NP-11-0036
August 4, 2011

Subject: Exelon Nuclear Texas Holdings, LLC
Victoria County Station Early Site Permit Application
Response to Request for Additional Information Letter No. 10
NRC Docket No. 52-042

Figure 1: Subsurface profile beneath the Unit 1 Reactor/Fuel building

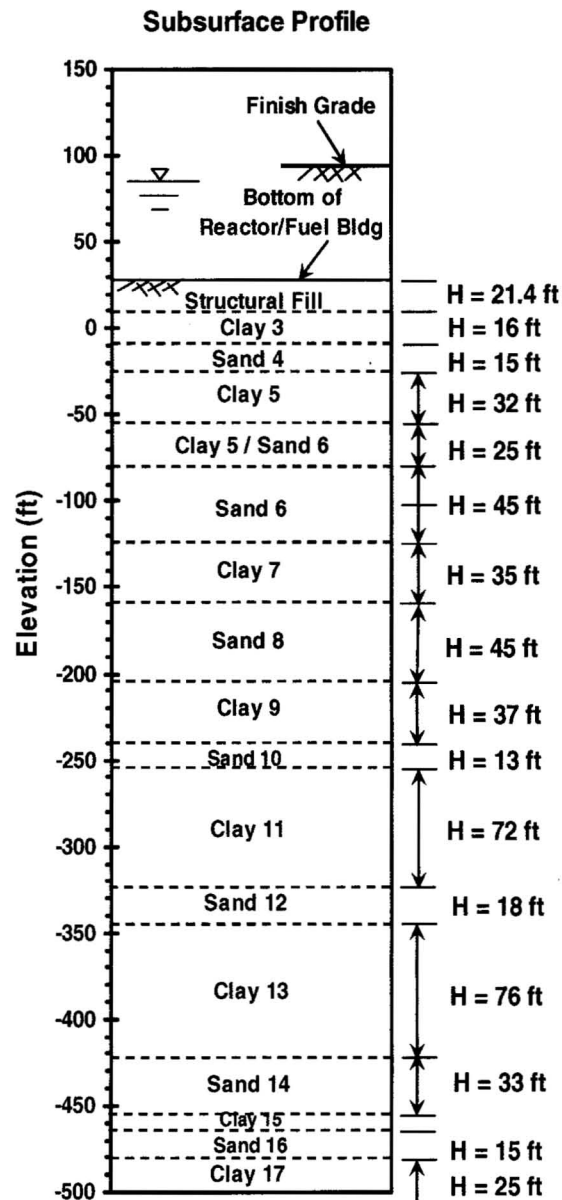
- a) SSAR Table 2.5.4-89 presents the calculated and allowable settlements. This table states that settlement is 'N/A.' However, the calculated settlements at the center of the reactor/fuel building are on the order of 5 inches. Explain how settlement will be addressed, and the allowable bearing capacities that were assumed. Please discuss the underlying assumptions associated with estimating settlement and provide a sample calculation including the layer profile, elastic moduli, and the assumed depth used in the analysis.

A sample settlement calculation, provided below, shows how the settlement of the Unit 1 Reactor/Fuel Building was computed. The main features of this sample settlement calculation are described here. Table 1 and Figure 1 of the calculation show the subsurface profile below the Unit 1 Reactor/Fuel Building. Table 2 shows the estimated preconsolidation pressure in each clay layer and the total applied pressure at the center of each layer, which is the sum of the in-situ overburden pressure and the applied structure pressure from the Unit 1 Reactor/Fuel Building. The preconsolidation pressure exceeds the total applied pressure in each clay layer. This is the basis of using an elastic approach to computing settlement in these overconsolidated clay layers.

The subsurface profile tabulated in Table 1 is shown in Figure 1.

Figure 1: Diagram of p-q for composites A and B from isotropically consolidated undrained (CIU) triaxial tests

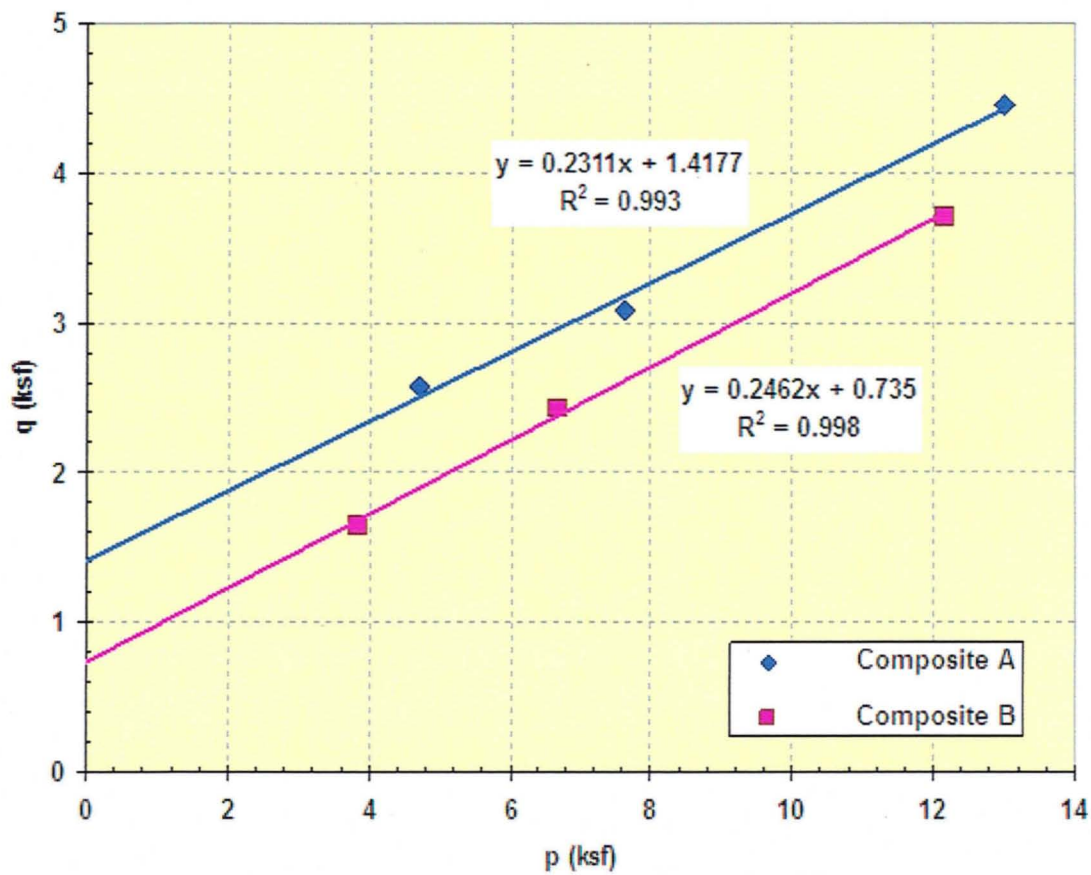
SSAR Subsection 2.5.5.1.9.1.1 states that the values of undrained shear strength obtained from the direct simple shear tests showed greater consistency than those obtained from the isotropically-consolidated undrained (CIU) saturated triaxial compression test. In accordance with 10 CFR 100.23(d)(4), please explain the possible reasons on why the CIU results were inconsistent.

Interpretation of the CIU shear strength data is based on the total stress (p-q) parameters, which are defined in SSAR Figure 2.5.5-9. Three specimens from each composite material were tested at three different confining pressures. Figure 1 is a graphic presentation of the p-q data. Considering the relatively similar properties (clayey sand versus lean clay with sand) and compaction characteristics of the two composites, Figure 1 shows a considerable difference between the undrained shear strengths of the two composites, i.e., 1.4 ksf for composite A versus 0.7 ksf for composite B for p=0 ksf.

Figure 1 - Boring/CPT locations with loose sand layer and the corresponding distances with respect to the eastern embankment

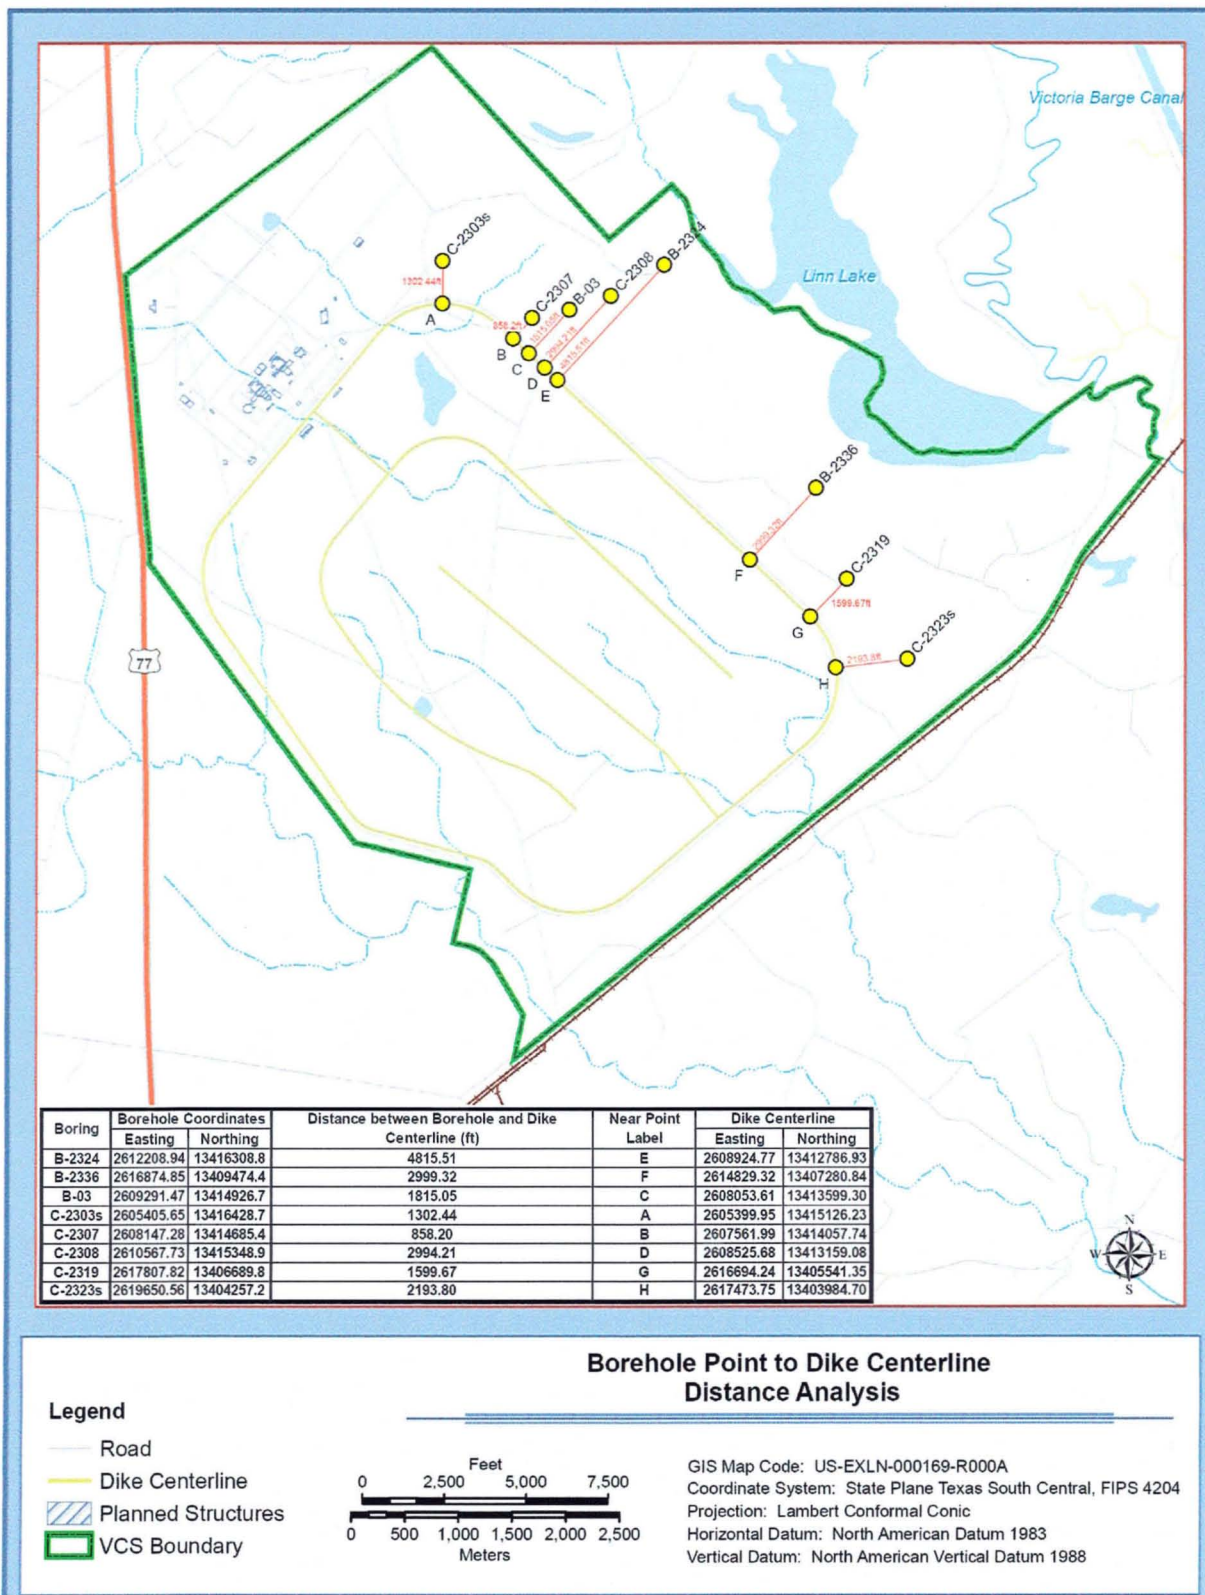
SSAR Subsection 2.5.5.1.11 indicates that shallow investigations disclosed the presence of a surficial loose layer of sand to the east of the cooling basin along the side of Linn Lake. The applicant concluded that this sand is beyond the limits of the embankment dam. In accordance with 10 CFR 100.23(d)(4), please explain how far beyond the limit this loose layer is located. Also, explain if this loose layer was considered in the slope stability analysis along the east embankment of the cooling basin.

Note that for completeness purposes, all data points including both sand and clay layers were tabulated in SSAR Tables 2.5.4-77, -79 and -81. For this RAI response, SSAR Tables 2.5.4-77, -79 and -81 are re-iterated but modified in Table 1 so that only the sand layers on the order of 10 feet deep, located to the east of the cooling basin are presented. Table 1 also shows the depth of the test points where liquefaction potential was observed. From Table 1, test locations B-03, B-2324, B-2336, C-2307, C-2308, C-2319, C-2303S, and C-2323S are where loose surficial sand layers are identified. Figure 1 illustrates the locations of these boring/CPT and the corresponding distances with respect to the eastern embankment.
